Meeting Agenda

Board of Zoning Appeals

Thursday, January 5, 2023

3. **Variance Request** To Allow Parking Within A Landscape Frontage Area, For The Property Located At 701 Cool Springs Boulevard (FZO §7.5).

880 Oak Meadow Drive - Overall Site Plan

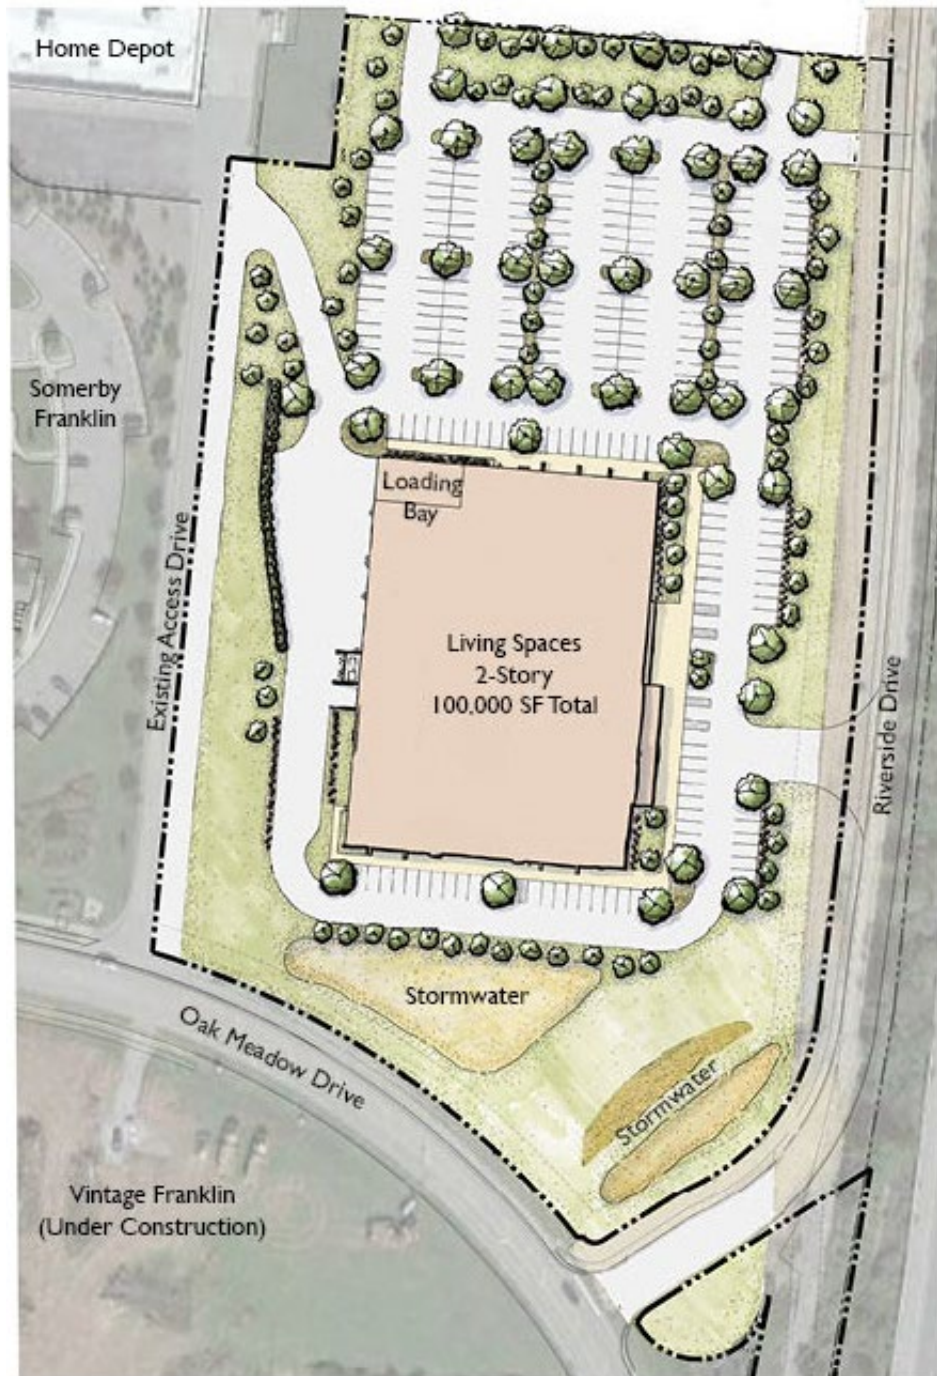
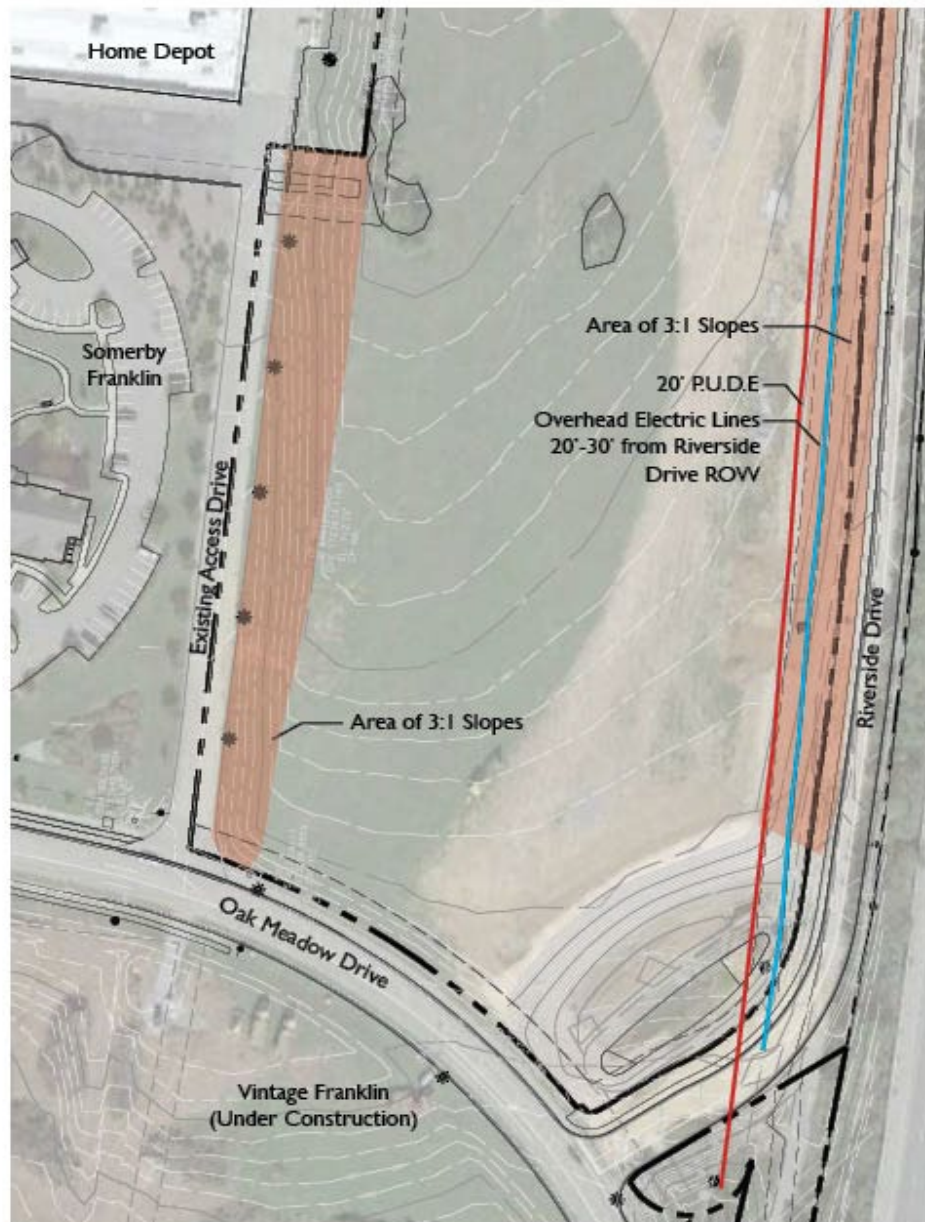
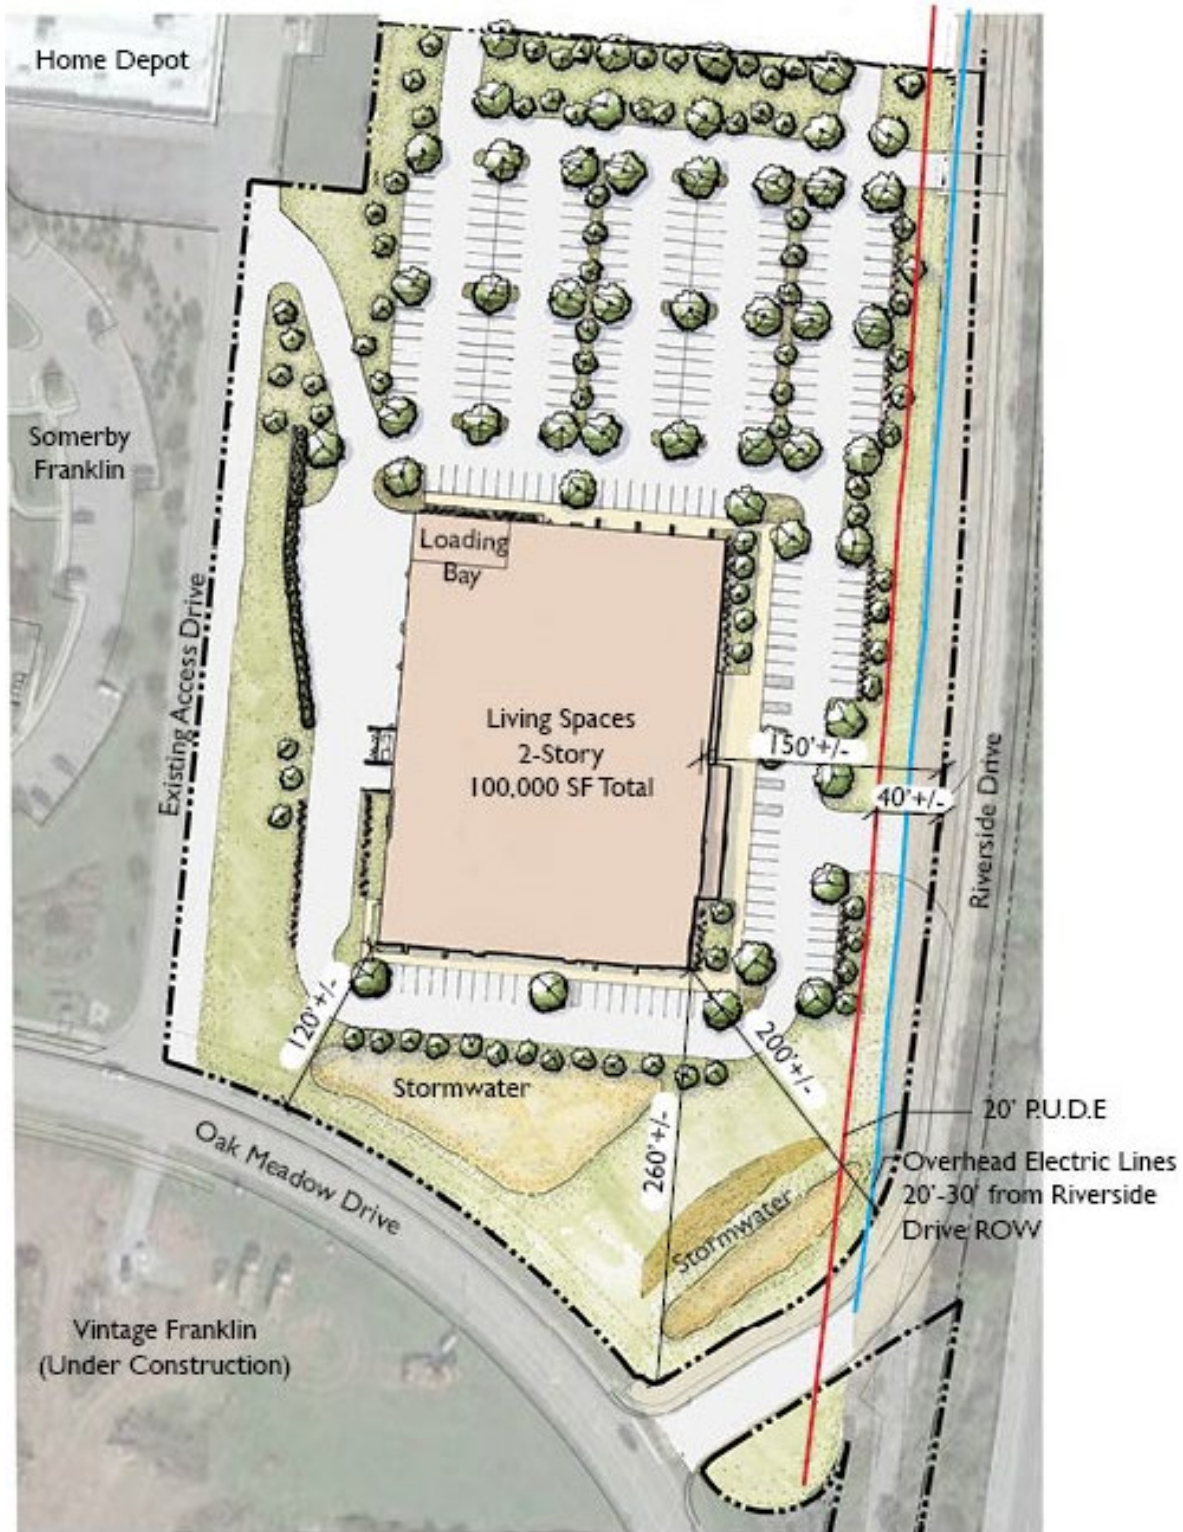
Since this item was deferred at the December BZA Meeting, staff has collected very limited new information regarding the site. After a meeting with the City of Franklin's Planning, Fire, and Engineering Departments for a thorough discussion of the site with the applicant, staff came to the same conclusion that with changes to the layout, the proposal could come closer to compliance with the Zoning Ordinance than the proposed plan. Lance Fittro of the City of Franklin Engineering Department drafted a Staff Suggested Site Layout which has been submitted as an exhibit with this request. This exhibit shows a plausible layout that would come closer to compliance with our Zoning Ordinance than the proposed plan for 880 Oak Meadow Drive.

There are some aspects of this property that qualify it as an exceptional situation, specifically steep slopes immediately adjacent to the right-of-way and access drive. However, it is not exceptional in a way that prevents the ability to accommodate development under the Zoning Ordinance for this specific request. In the absence of a site plan application, staff believes that there are multiple ways that this site could be designed differently, so that ADA parking can be placed to the side or behind the principal building and fire access can be provided, in order to comply with the Zoning Ordinance. Staff finds this criteria is not met.

Since the item was deferred in December, discussion and analysis have shown that it is completely possible to provide the necessary parking with parallel parking in the frontage and/or necessary parking to the side or behind the building, which would be in compliance with the Zoning Ordinance. The necessary ADA Parking can be provided as parallel parking, as shown in the Staff Suggested Site Layout exhibit. This is shown in the Staff Suggested Site Layout exhibit. There is not an exceptional situation with the site itself that prevents compliance with the Zoning Ordinance in this situation. Staff still considers this request a matter of preference, and that the

Staff finds that the strict application of the Zoning Ordinance would not result in peculiar and exceptional practical difficulties to or exceptional or undue hardship upon the owner of the property. The variance request is unique to the applicant's proposed plan and not generally to all potential designs for the site, meaning that the applicant could design a plan for the site that meets the requirements of the Zoning Ordinance. It is the expectation of the City that an applicant designs their site in a way that meets the requirements of the Zoning Ordinance, and not use the variance process to avoid inconvenience or financial hardship. Staff finds that the proposed plan introduces a self-imposed hardship, one that can be resolved by redesigning to meet the zoning ordinance. Staff finds this criteria is not met.

As stated with the previous criteria, discussion and analysis have shown that it is completely possible to provide the necessary parking with parallel parking in the frontage and/or necessary parking to the side or behind the building, which would be in compliance with the Zoning Ordinance. This is shown in the Staff Suggested Site Layout exhibit. There is not a provision enacted under the Zoning Ordinance that would result in undue hardship upon the owner of the property in this case. Staff still considers this request a matter of preference, and that the "hardship" is self-imposed in this situation. Staff finds this criteria is not met.

The design of this site would not be a detriment to the public good, but it would impair the intent of the Zoning Ordinance. The Zoning Ordinance introduced the requirements for Frontage starting with the 2019 Zoning Ordinance update, as a direct response to the adoption of Envision Franklin in 2017. Two of the core Guiding Principles are Exceptional Design and Vibrant Neighborhoods. One characteristic of Exceptional Design as outlined in Envision Franklin is that parking should be secondary to the building and its relationship to the street, and that views from the street should not be of parking lots. One characteristic of Vibrant Neighborhoods as outlined in Envision Franklin includes pedestrian-friendly neighborhoods that make walking and biking more enjoyable along streets. The intent of the Zoning Ordinance is to reinforce the principles of Envision Franklin by keeping parking to the side or behind principal buildings. This site is not designed in a way that meets the intent of the ordinance. Staff finds this criteria is not met.

RECOMMENDED MOTION: Staff recommends the Board of Zoning appeals move to deny the **Variance Request** To Allow Parking Within The Riverside Drive Frontage Area For A Proposed Principal Building, and deny a **Variance Request** To Allow Parking Within The Oak Meadow Drive Frontage Area For A Proposed Principal Building, and defer a **Variance Request** To Increase The Maximum Front Yard Setback from 30 Feet to 150 Feet, For The Property Located At 880 Oak Meadow Drive because the criteria for granting a variance were not supported by sufficient evidence. Without more information on the stormwater management needs of the site along Oak Meadow Drive, Staff cannot determine the setback needs along Oak Meadow Drive.
